Notice of Modification

Section 75W of the *Environmental Planning and Assessment Act 1979*

Project approval 10_0014 for the Badgerys Creek Quarry and Brick Making Project, granted by the Deputy Director-General, Development Assessment Systems and Performance as delegate of the Minister for Planning and Infrastructure on 27 September 2011.

Figure 2: Road Noise Receiver ID

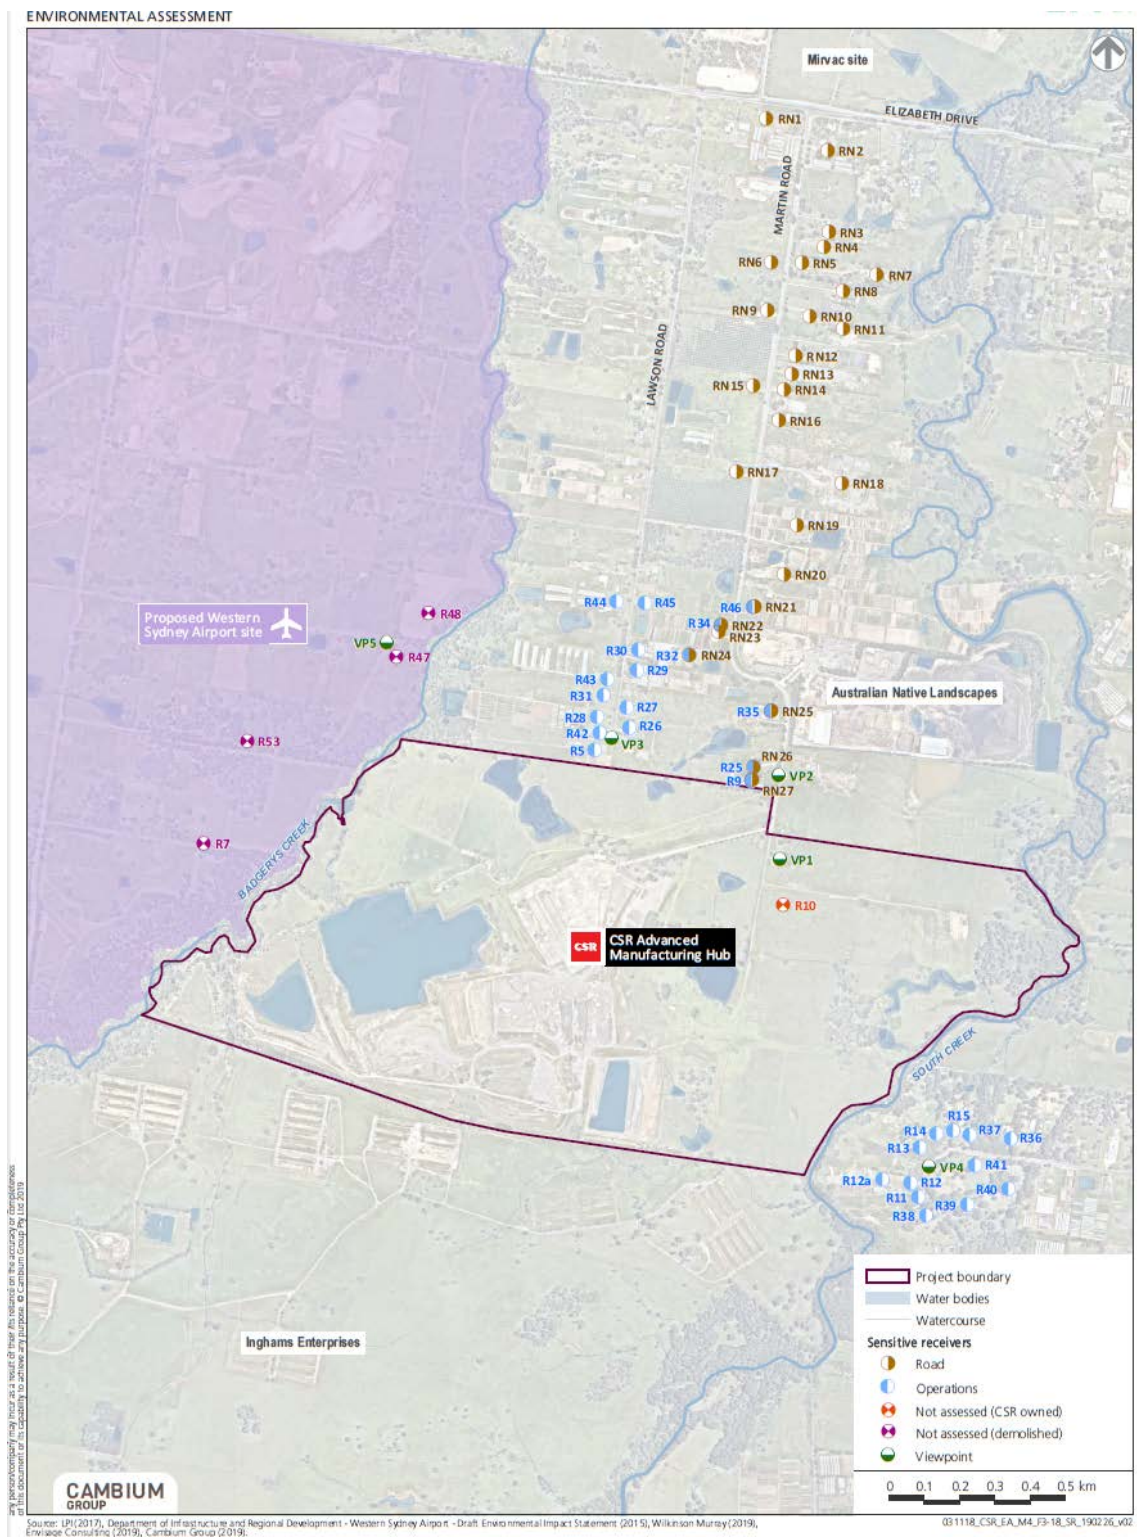
62. In Appendix 2:
- a) insert the label “**Figure 1: Receiver ID**” beneath the existing figure; and
 - b) after Figure 1, insert the following:

Figure 1: Project Layout Overview

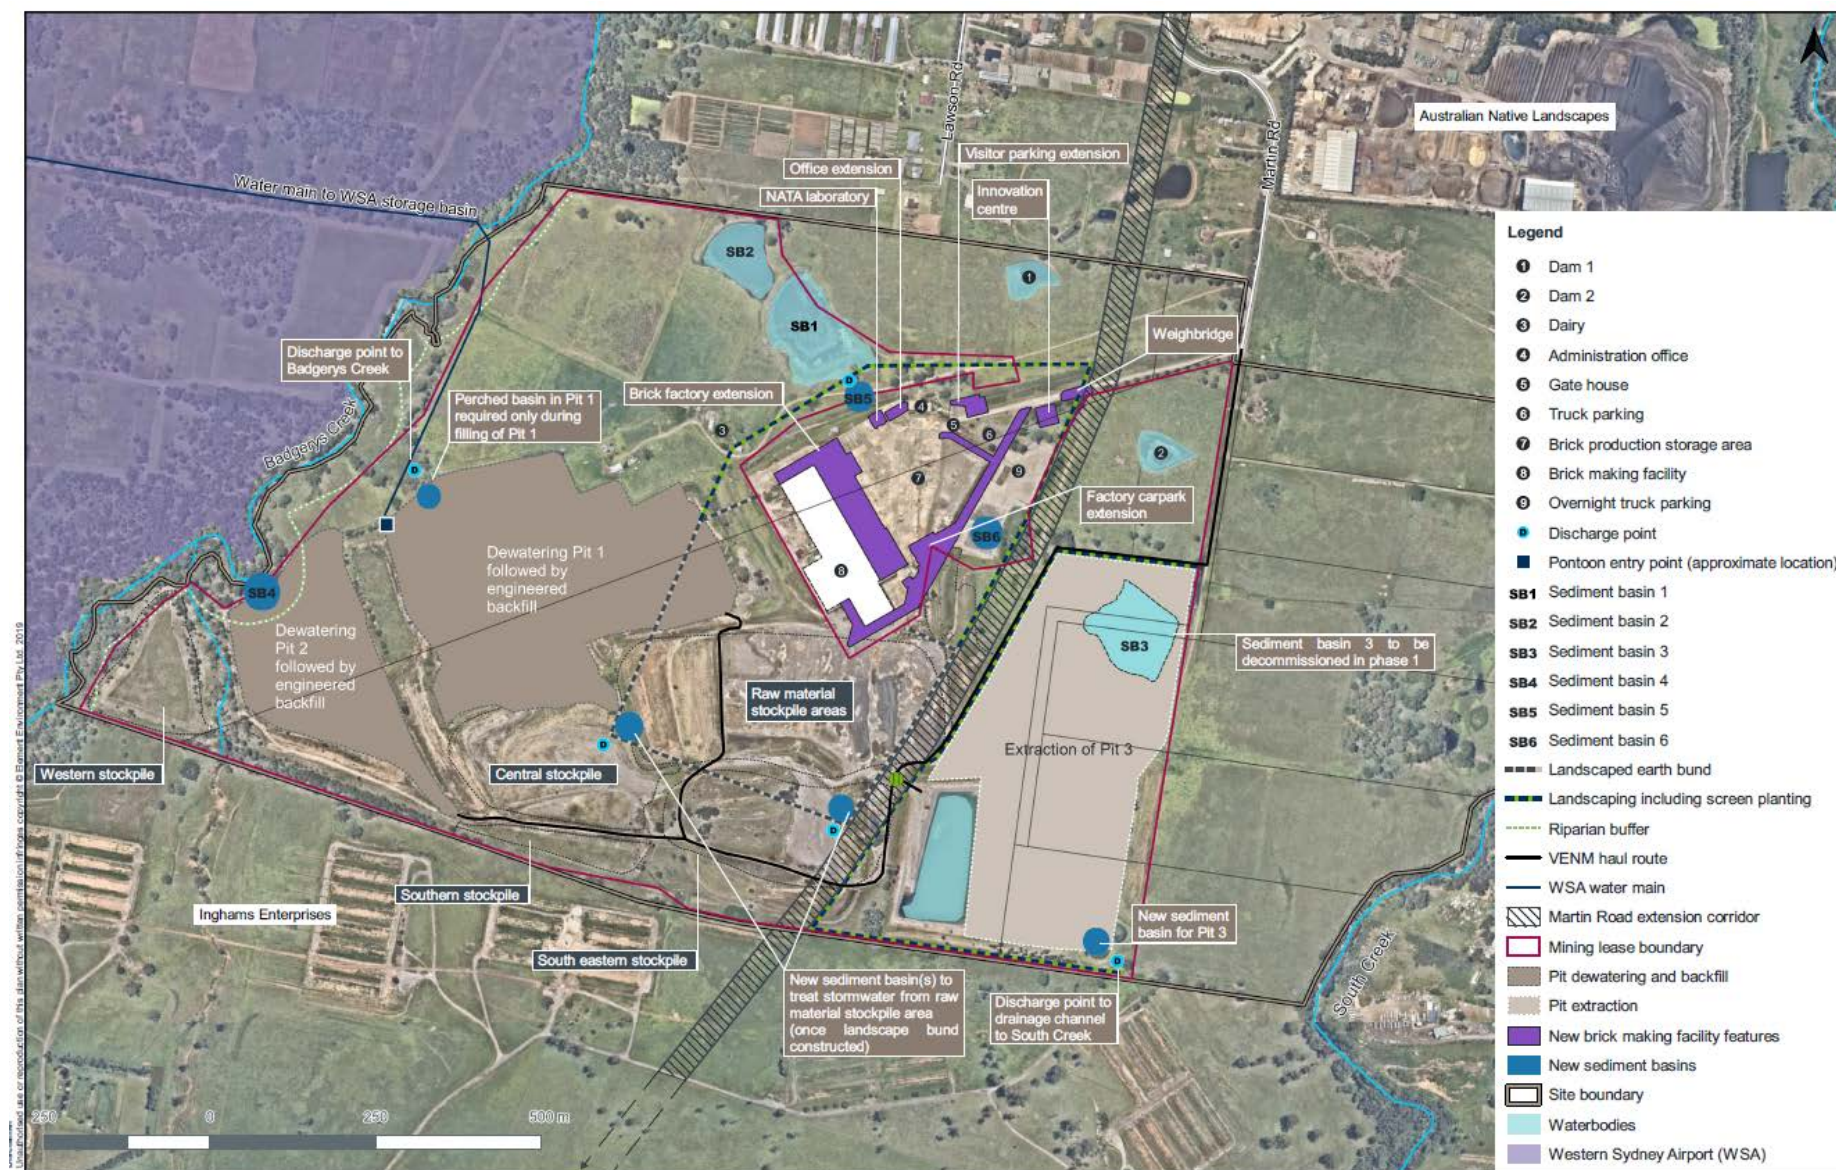
63. In Appendix 3, delete figure, including the heading, and replace with the following:

Figure 1: Phase 2 Rehabilitation

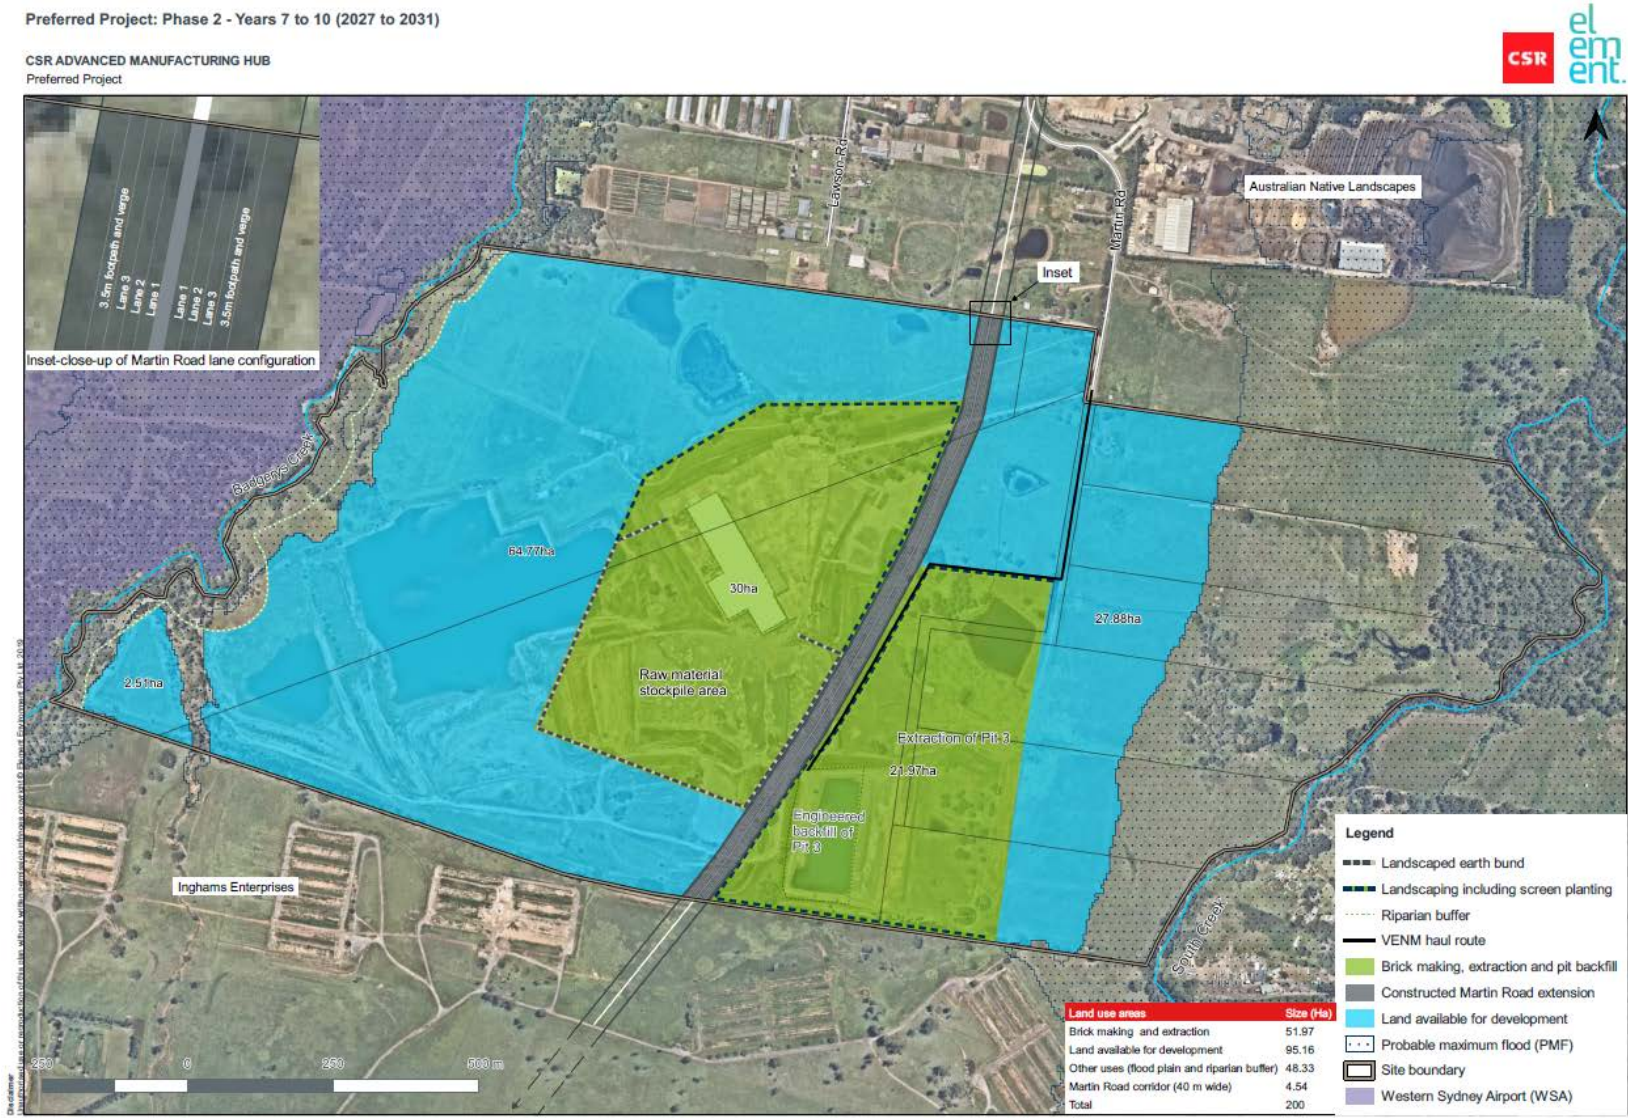
64. In Appendix 4 delete the figure and replace with the following:
